VSP-30
May 20, 1981

VENDOR SERVICE PUBLICATION

Subject: Bendix Service Bulletins 599A, 609A, 610,
613, 614

SERVICE BULLETIN NO. 599A
(Supersedes Service Bulletin No. 599)
Engineering Aspects are
FAA Approved

Figure 2. Checking Flyweight to Stop Pin Clearance

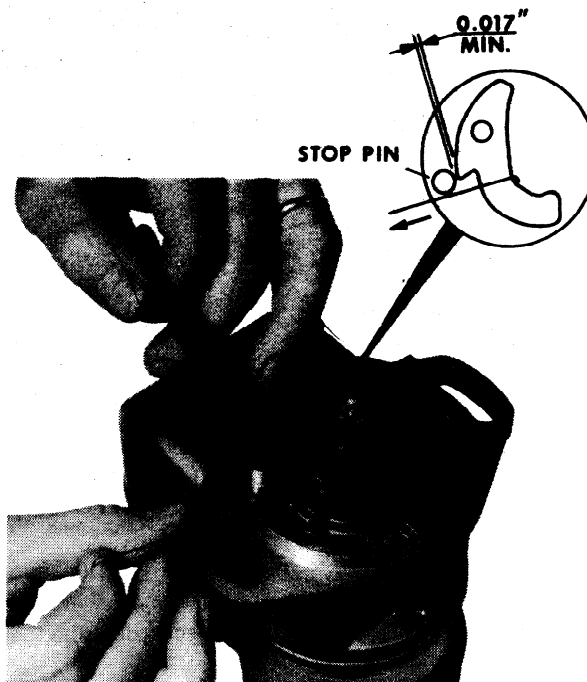
- a. Bend the end of a stiff wire into a right angle 1/8 inch long, maximum.
- b. Position impulse coupling so that heel of flyweight (see figure 1) is adjacent to stop pin. Reach

between cam and flyweight with bent wire, as near as possible to the stop pin, and pull outward on the flyweight as shown in figure 2.

c. While pulling flyweight outward, insert feeler gages to measure the clearance between the heel of the flyweight and the stop pin, assuring a minimum of 0.017 inch exists.

d. If less than 0.017 inch clearance exists, this is cause for immediate rejection of the impulse coupling cam assembly, or possibly the entire impulse coupling. Refer to the applicable Magneto Overhaul Instructions for inspection procedures to determine if other impulse coupling parts are still serviceable.

Figure 6. Flyweight Tail Condition Check

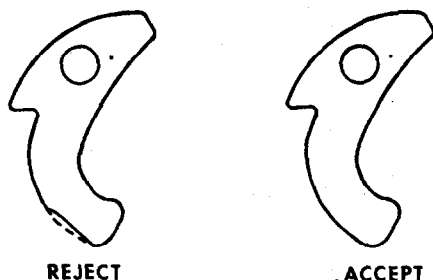
4. Flyweight tail condition must be given a visual examination to determine if flyweight is still serviceable. The surface at the apex of the beveled edge must blend smoothly with the outer contour of the flyweight. No flattening, denting or chipping is permissible. Any irregularity of this surface is cause for immediate rejection of the cam assembly. (See figure 6)

Figure 1.

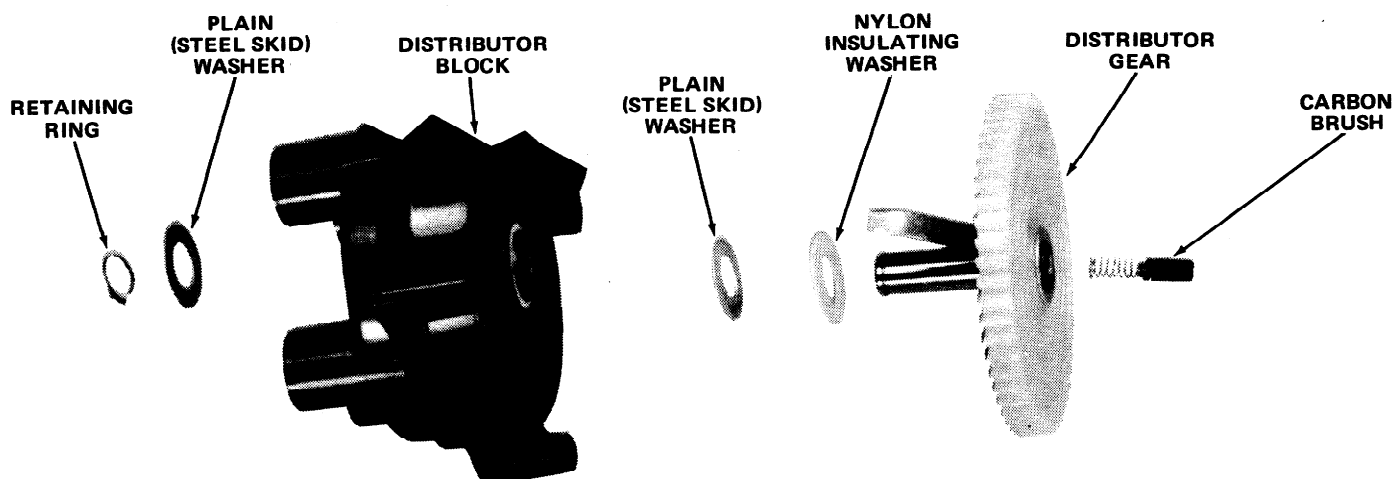
This bulletin announces availability of an improved, insulated distributor gear in kit form which is interchangeable between the D-2000/D-2200 & D-3000/D-3200 series magnetos. The kit includes all parts (except distributor block) as identified in figure 1.

Assembly sequence of the gear kit to distributor block is shown in Figure 1.

Figure 1. Location of Identification Mark

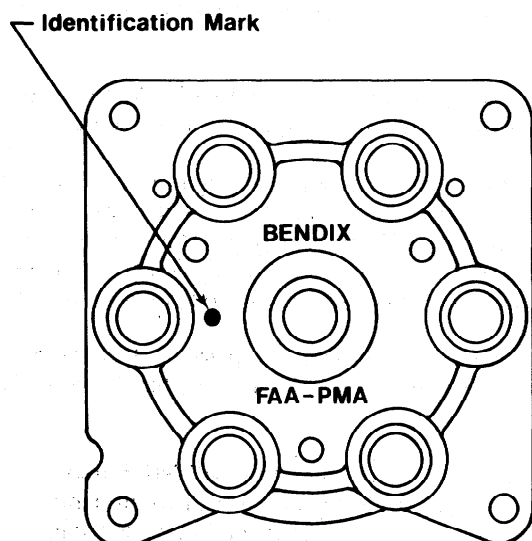
The new "Gripper Bushing" will eliminate the possibility of the bushing becoming loose. The "Gripper Bushing" block can be identified by a circular shaped mark 0.188 inch \pm 0.031 inch in diameter raised 0.010 inch to 0.030 inch above the surface of the block. This mark is located on the tower side of the block, as indicated in figure 1.

Figure 6. Distributor Gear/Block Exploded View

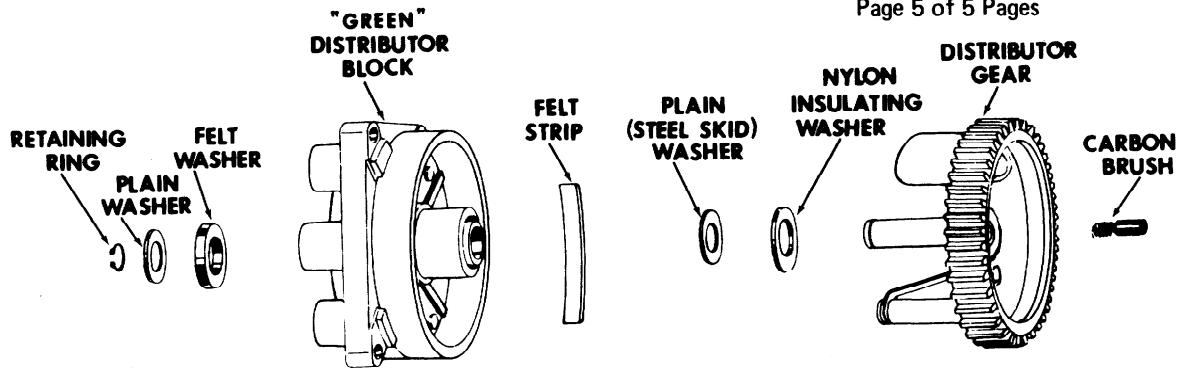
8. For reassembly, reference figure 6 and proceed as follows:

Figure 1 Defect

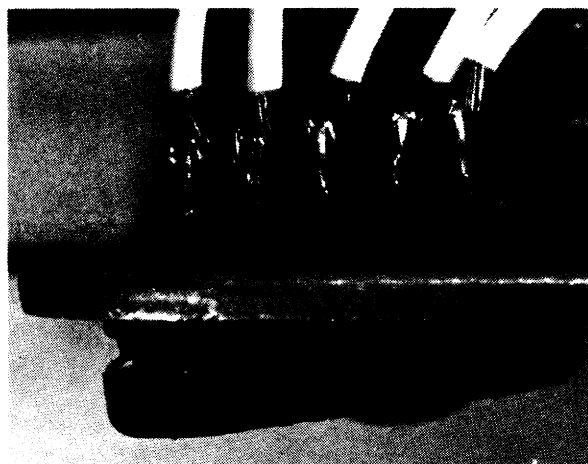
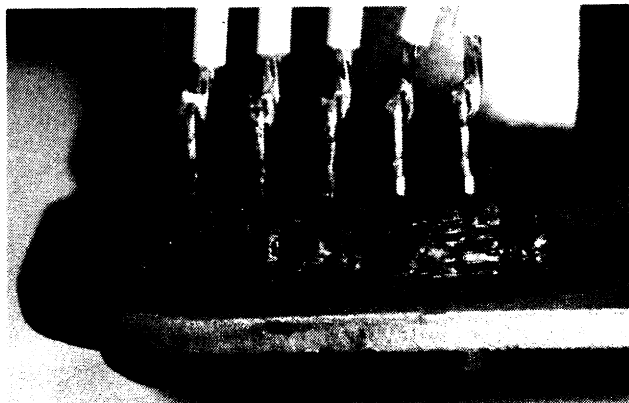
Bushing (connector), P/N 10-382943, may become loose in the vibrator plate and cause the grounding of both magnetos with possible loss of ignition. See figure 1 (defect).

5. Use RTV (Silicone rubber sealant, or equivalent, Dow Corning Corp., Midland, Mich. 48640) to seal terminal bushing to the mounting plate. Apply a small bead completely around the bottom of bushing to secure the bushing to the plate as shown in figure 2 (repaired). If RTV is not available, use either Hysol, Epoxi-Patch Kit (general purpose), Hysol Corp., Olean, NY or Conap, Easyepoxy Kit (K20 general purpose) 1405 Buffalo St., Olean, NY, or equivalent.
